Product Change Notification

Product Group: DIODES / January 19th, 2018 / PCN-DD-002-2018 Rev 0

Additional assembly site for TO-220FullPAK package

3L TO-220FullIPAK

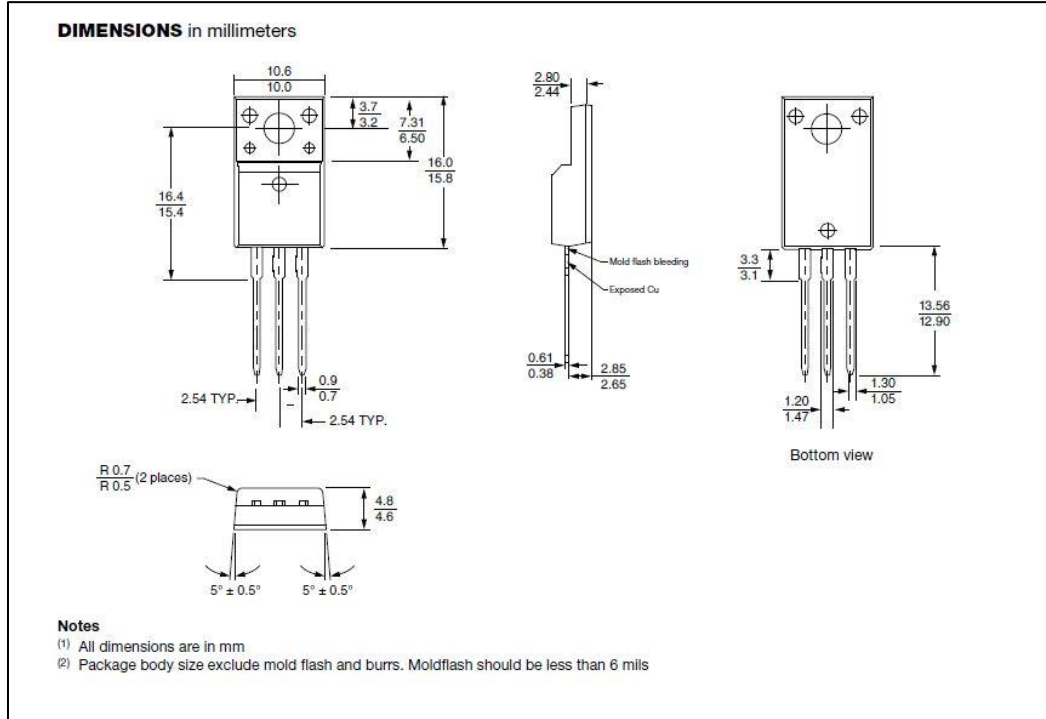
ACTUAL	ADDITIONAL
Die Attach Solder (Thyristors)	PbSn	PbSnAg
Junction Coating (Thyristors)	Yes	No

3L TO-220FullPAK

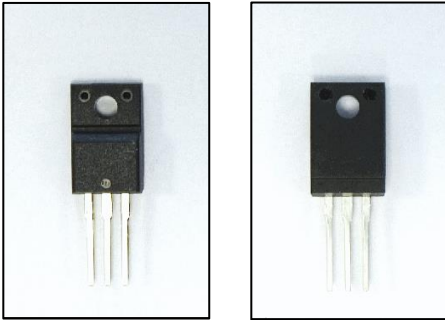
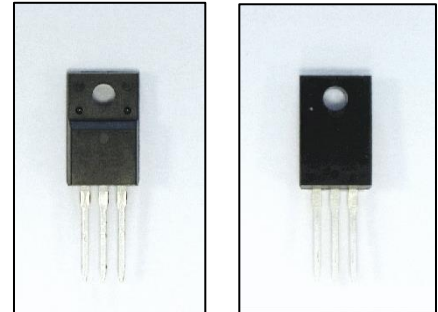
DESCRIPTION OF CHANGE: In order to meet increasing demand of Rectifiers, Vishay Diodes Division is introducing an additional assembly line at a new subcontractor in China for commercial TO-220FullPAK Part Numbers.
 The new subcontractor has received international quality system and environmental compliance certification ISO9001 and ISO14001.
 Bill of materials is shown in annex 2 while Package Outline Dimensions will be consolidated as illustrated in annex 3.
 UL certification (File E78996) update for new assembly site is pending.
 Taking the chance of this capacity expansion, product nomenclature will be harmonized: Vishay Diodes Division will discontinue the Part Numbers with PBF suffix and keep active the Halogen-free version only (-M3 / -N3 suffix).
